United States Patent and Trademark Office

APPLICATION NO.	F	ILING DATE	FIRST NAMED INVENTOR	ATTORNEY DOCKET NO.	CONFIRMATION NO.	
10/817,457	17,457 04/03/2004		Oswald Friedmann	0815 A US	1602	
20676	7590	04/19/2006		EXAMINER		
ALFRED J			RODRIGUEZ, SAUL			
4729 CORNELL ROAD CINCINNATI, OH 452412433				ART UNIT	PAPER NUMBER	
•				3681	3681	
				DATE MAIL ED. 04/10/2004

Application No.	Applicant(s)					
	Office Assista Occurrence	10/817,457	FRIEDMANN, OSWALD					
	Office Action Summary	Examiner	Art Unit					
		Saúl J. Rodríguez	3681					
The MAILING DATE of this communication appears on the cover sheet with the correspondence address Period for Reply								
A SHORTENED STATUTORY PERIOD FOR REPLY IS SET TO EXPIRE 3 MONTH(S) FROM THE MAILING DATE OF THIS COMMUNICATION. - Extensions of time may be available under the provisions of 37 CFR 1.136(a). In no event, however, may a reply be timely filed after SIX (6) MONTHS from the mailing date of this communication. - If the period for reply specified above is less than thirty (30) days, a reply within the statutory minimum of thirty (30) days will be considered timely. - If NO period for reply is specified above, the maximum statutory pe

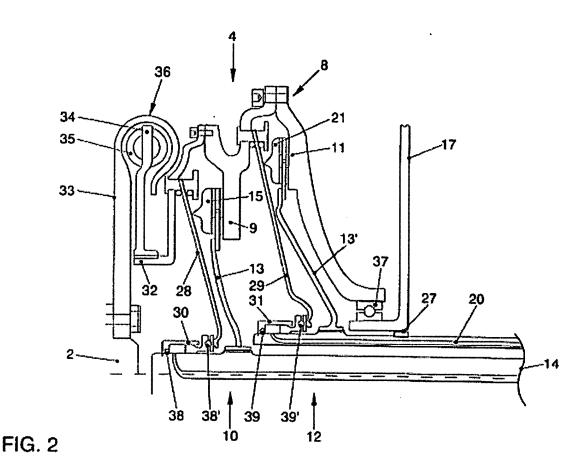
Claims 1, 3, 10-12, 14 and 17 are rejected under **35 U.S.C. 102[2]** as being anticipated by Damm et al. ('483 – published 2/6/03).

Damm discloses a multiple clutch unit (Fig. 2) comprising a first clutch (13), a first input shaft (14), a second clutch (13'), a second clutch input shaft (20), a first piston/cylinder unit (30, 38), a non-rotatable but axially moveable connection (Col. 8, lines (65-67; Col. 9, lines 1-13), an axially fixed second cylinder and moveable piston (31, 39), a bearing device (39'), and a torsional vibration damper (35).

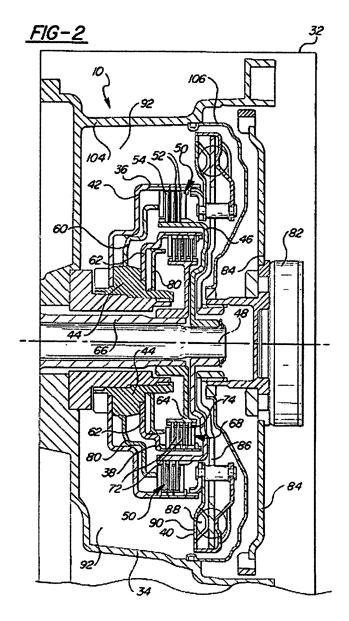
Damm does not show a multiple disc clutch. However, multi-plate clutches are conventional in dual-clutch arrangements. For example, Merkel et al. discloses a conventional multiple clutch unit (Fig. 2) comprising a plurality of shafts (44, 46, 64, 82,

84), first and second transmission input shafts (48, 66), piston cylinders (60, 80), a torsional vibration damper (40), multi-plate clutches (50), and a shaft coupling element (64).

Then, it would have been obvious to a person of ordinary skill in the art at the time the invention was made to use multiple-disc clutches in the device of Damm in view of Merkel to increase the torque capacity of the assembly.
